**ADDENDUM NO. 2
July 6, 2023**

**Taxiway A Reconstruction – Phase 3
Duluth International Airport (DLH)
Duluth, Minnesota
City of Duluth No. 23-4409
AIP No. 3-27-0024-074-2022
SP No. A6901-205
SEH No. DULAI 168804**

From: Short Elliott Hendrickson Inc.
3535 Vadnais Center Drive
St. Paul, MN 55110-3507
651.490.2000

SHEET
E-107

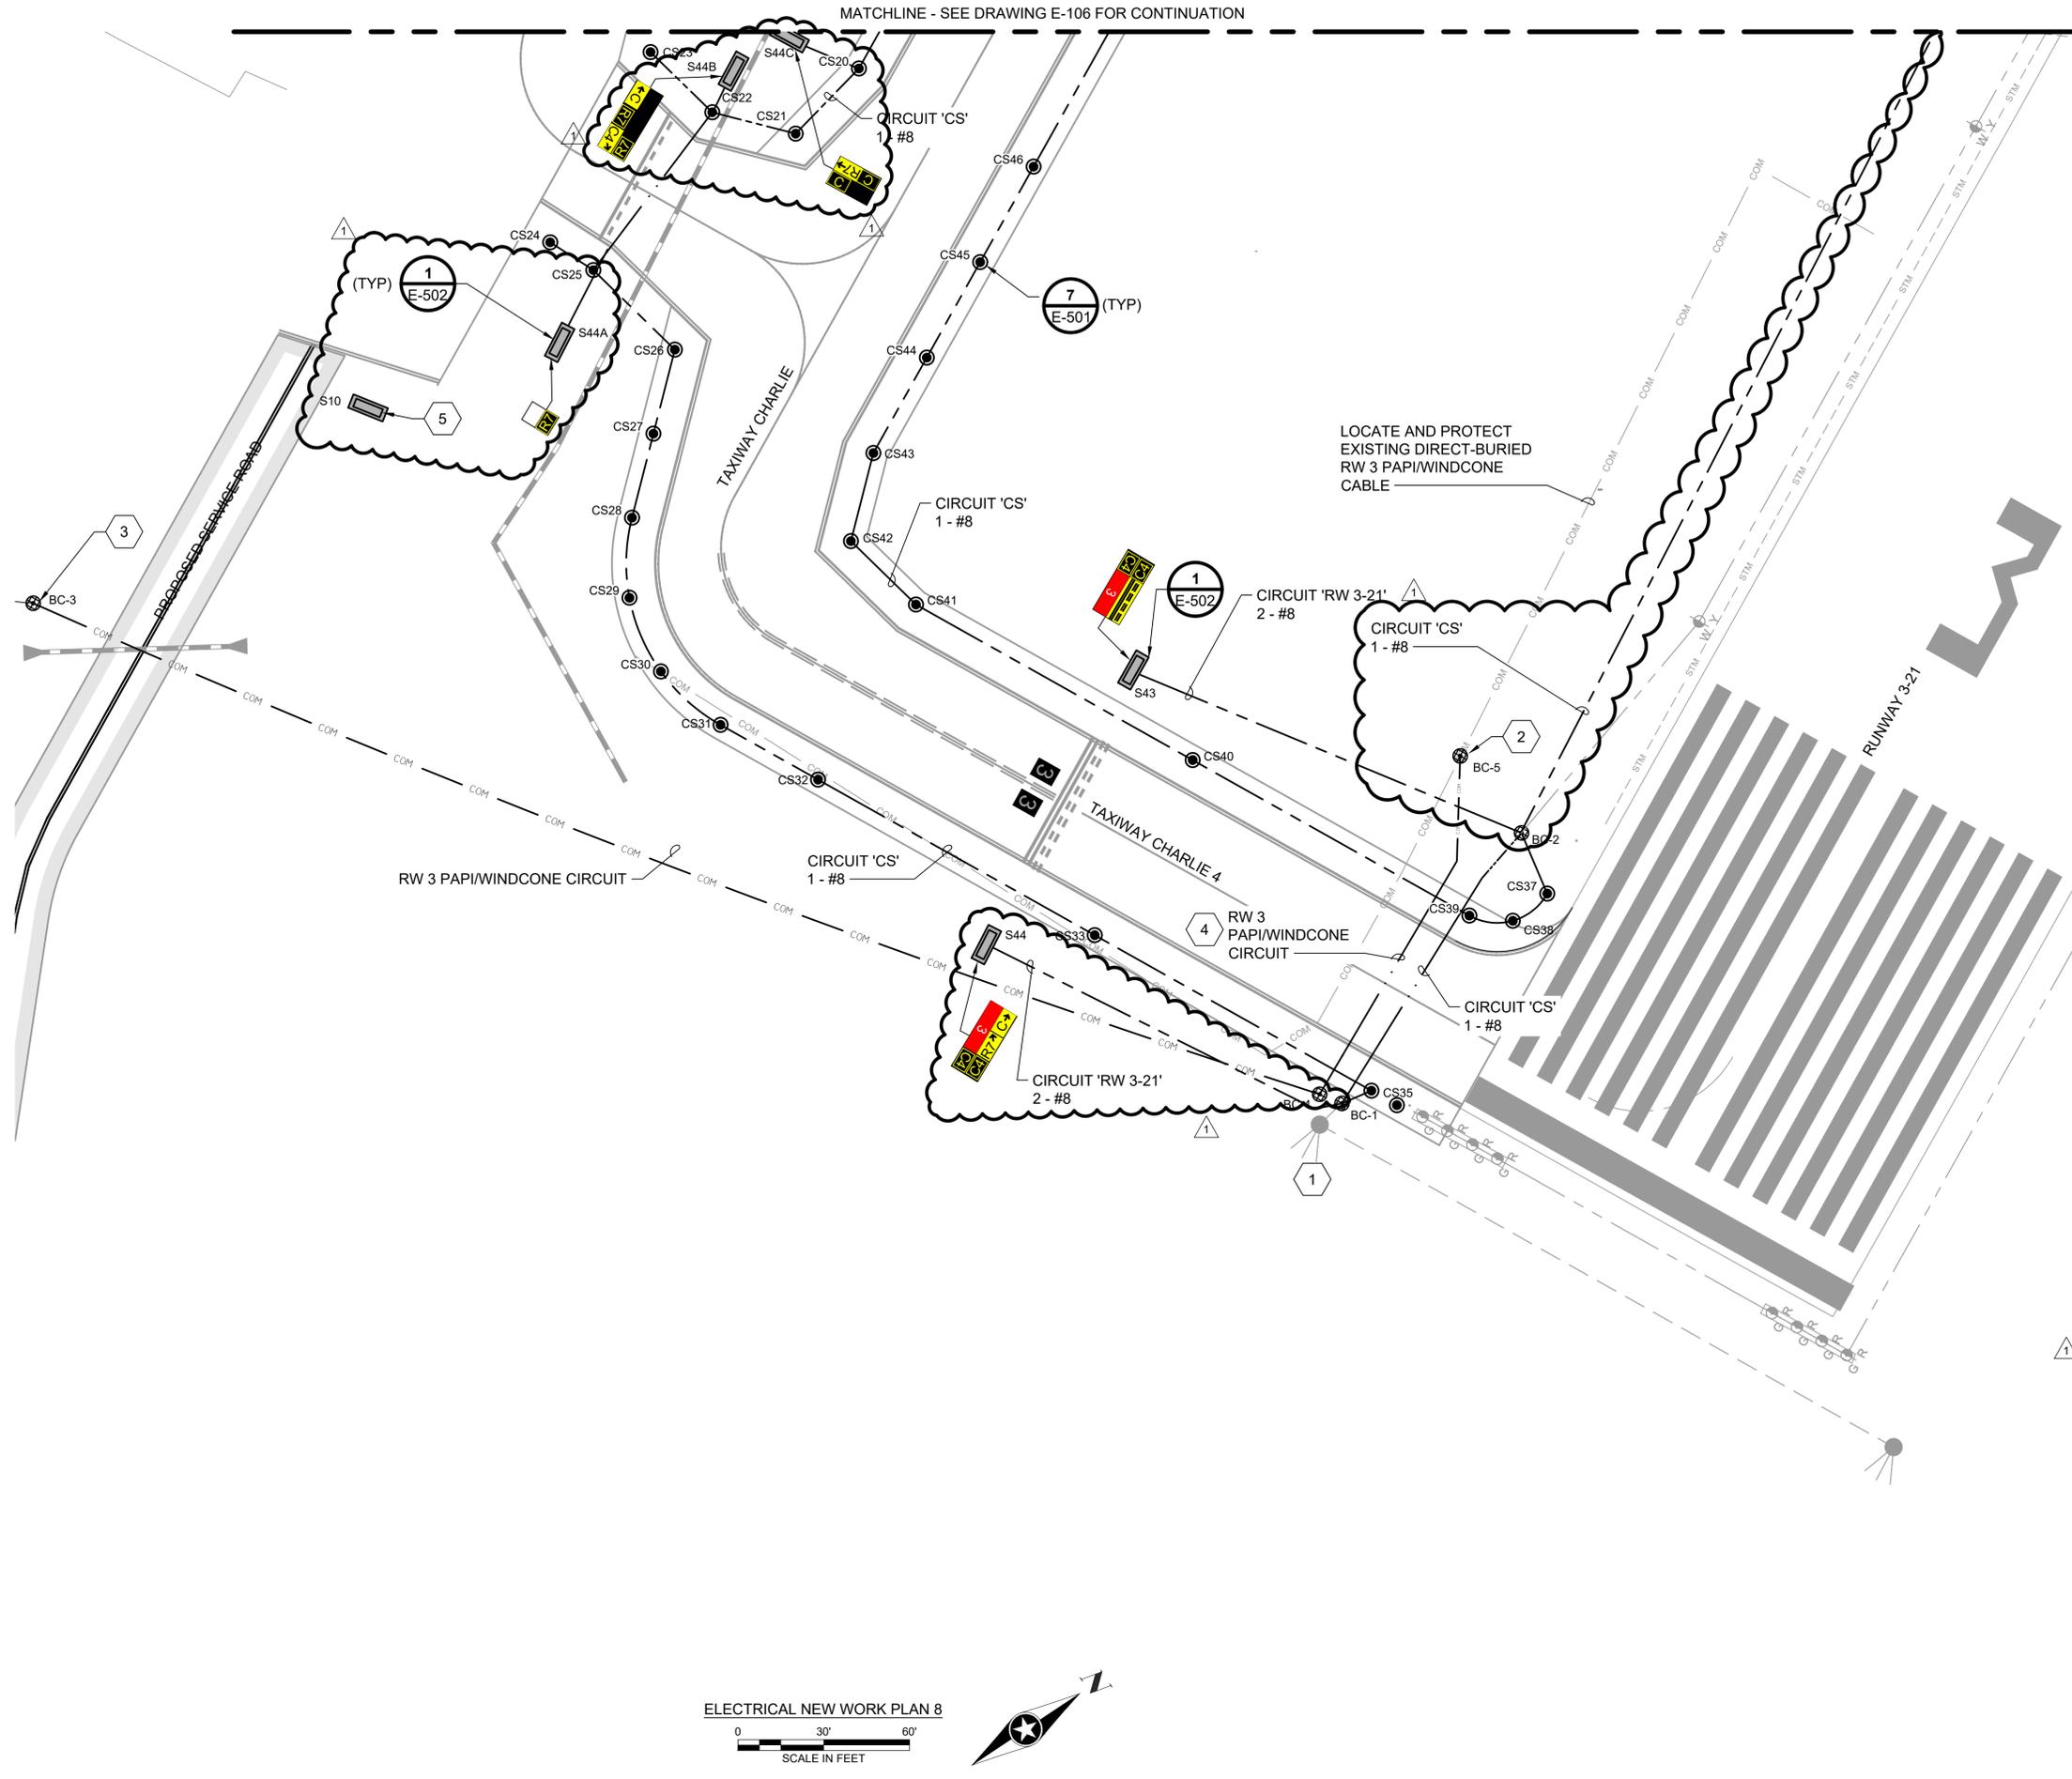
16. Drawing E-107 Electrical New Work Plan 7 – Drawing now shows circuitry routed to existing sign fixture. Keyed note locations for keyed note 1 updated. DELETE in its entirety and REPLACE with the attached revised drawing.

ELECTRICAL SIGNAGE & TAXIWAY LIGHT FIXTURE LOCATIONS

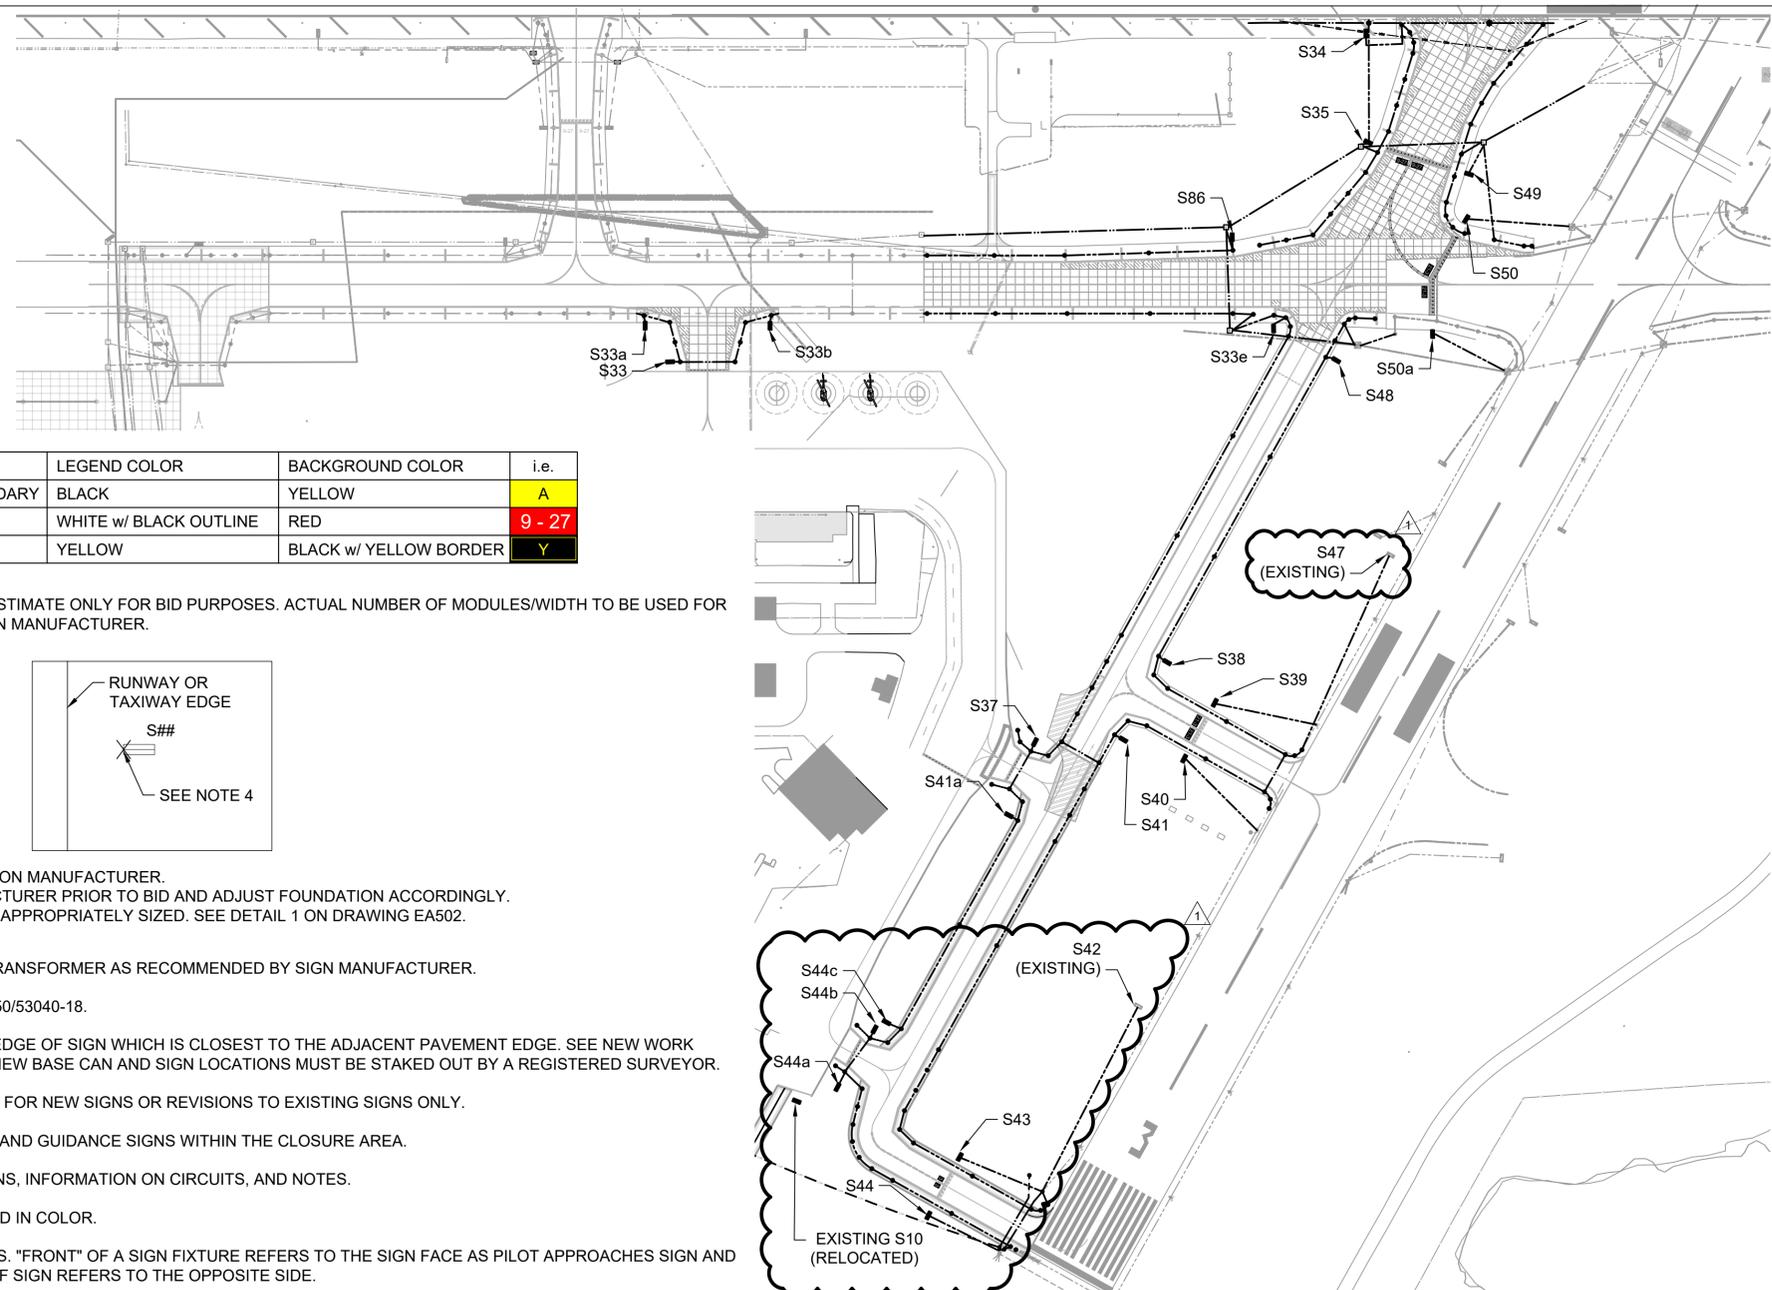
18. Drawing E-109 Electrical Signage & Taxiway Light Fixture Locations – Tabulation updated for revised and new airfield sign locations. Tabulation updated for revised and new light fixture locations. DELETE in its entirety and REPLACE with the attached revised drawing.

SHEET TITLE ELECTRICAL SIGNAGE PLAN

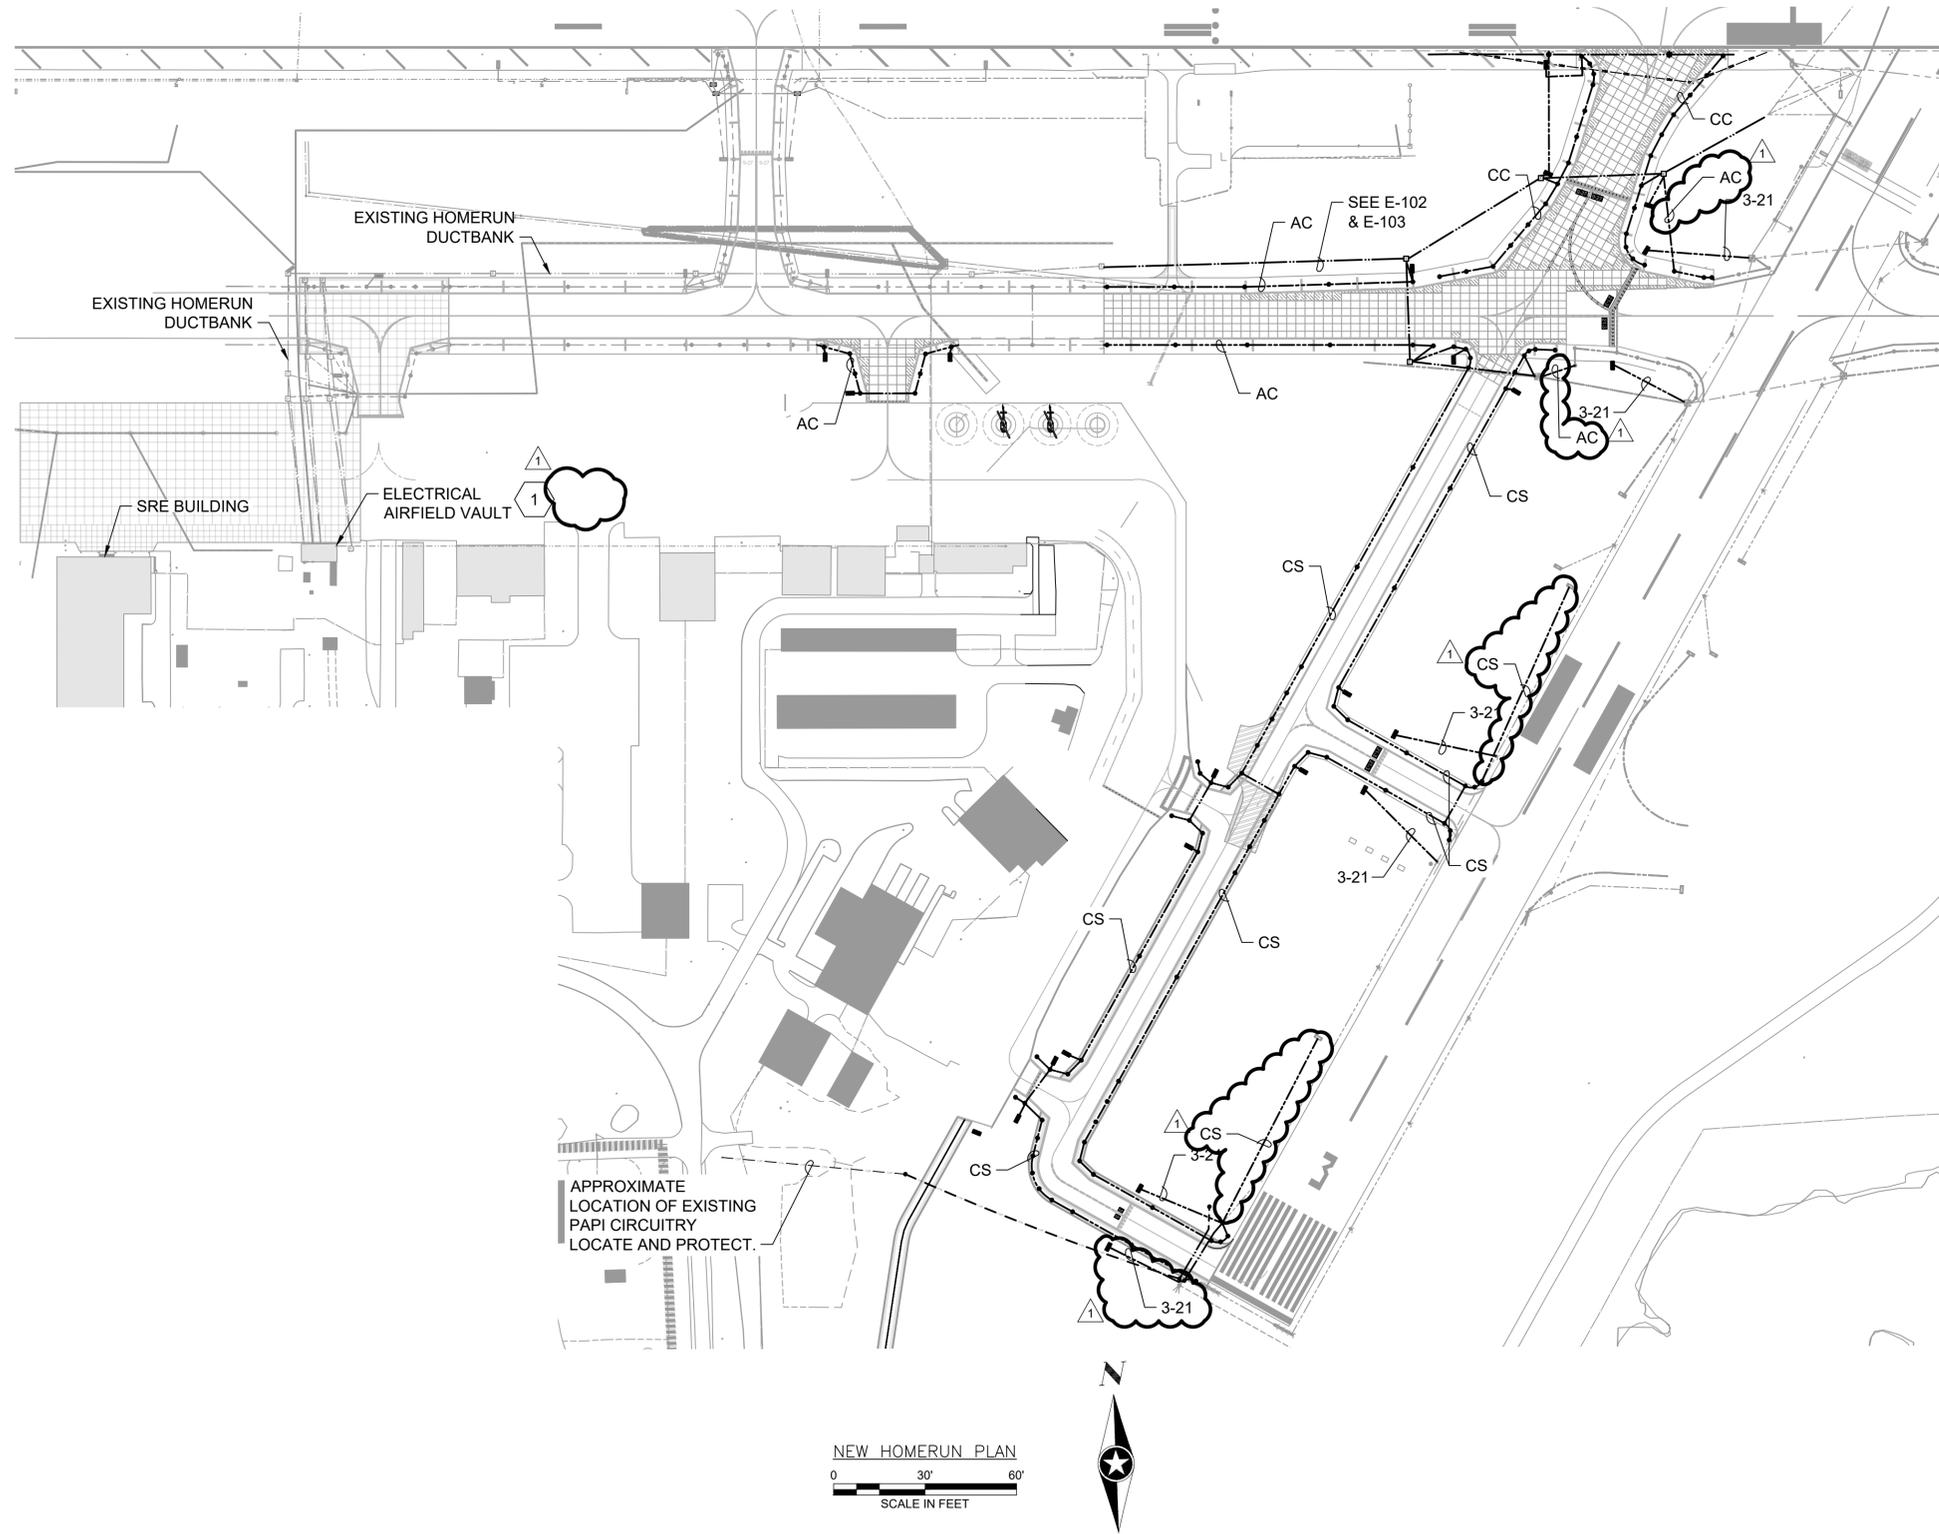
19. Drawing E-111 Electrical Signage Plan – Updated signage according to recent taxiway nomenclature updates. DELETE in its entirety and REPLACE with the attached revised drawing.
